# Access Compliance Report

## Public Rights-of-Way

### (Curb Ramps)

Intersection ID: 10035679	Main Street: RED_RUST_LN	Cross Street: N/A	Location: E
ADA ID: F8788FCBD0C8	Ramp Type: Perp	Initial Pass/Fail: Fail	Overall Compliance: No
		Severity Score: 12.5

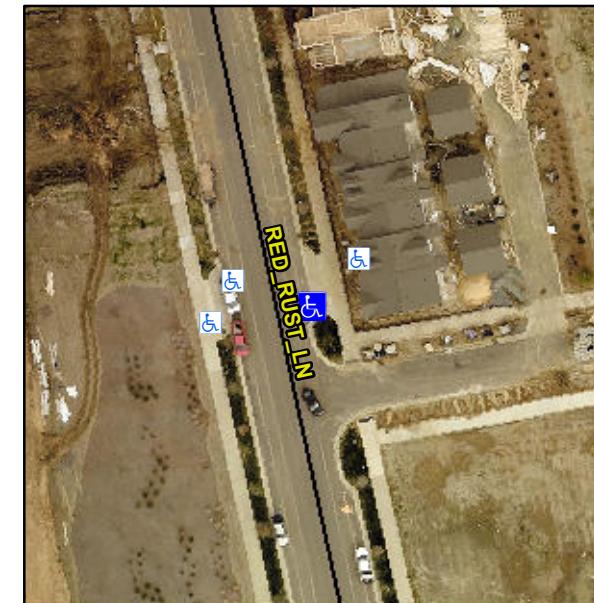
**Not Found, R304.2.2**

Compliance	Description	Data	Compliance	Description	Data
N/A	Ramp Length (in)	67.0	No	Ramp Slope (%)	10.3
Yes	Ramp Width (in)	60.0	Yes	Ramp XSlope (%)	0.4
N/A	Flare Type LT	N/A	N/A	Flare Type RT	N/A
N/A	Flare Slope LT (%)	N/A	N/A	Flare Slope RT (%)	N/A
N/A	Flare Traversable LT?	N/A	N/A	Flare Traversable RT?	N/A
N/A	Landing Length (in)	N/A	N/A	DWS Provided?	N/A
N/A	Landing Width (in)	N/A	N/A	DWS Contrast?	N/A
N/A	Landing Slope (%)	N/A	N/A	DWS Length (in)	N/A
N/A	Landing X Slope (%)	N/A	N/A	DWS Full Width?	N/A
N/A	Landing Curb? (Y/N)	N/A	N/A	DWS Offset (in)	N/A
N/A	Shared Landing?	N/A			
N/A	Gutter Ponding?	N/A	N/A	Gutter Slope (%)	N/A
N/A	Gutter Lip Ht (in)	N/A	N/A	Gutter X Slope (%)	N/A
N/A	Painted X Walk1?	No	N/A	Painted X Walk2?	N/A
	X Walk 1 Direction	To NW		X Walk 2 Direction	N/A
N/A	X Walk 1 Width (in)	N/A	N/A	X Walk 2 Width (in)	N/A
	X Walk 1 Slope (%)	3.9		X Walk 2 Slope (%)	N/A
	X Walk 1 X Slope (%)	3.4		X Walk 2 X Slope (%)	N/A

**Remove & Replace Entire Ramp.**
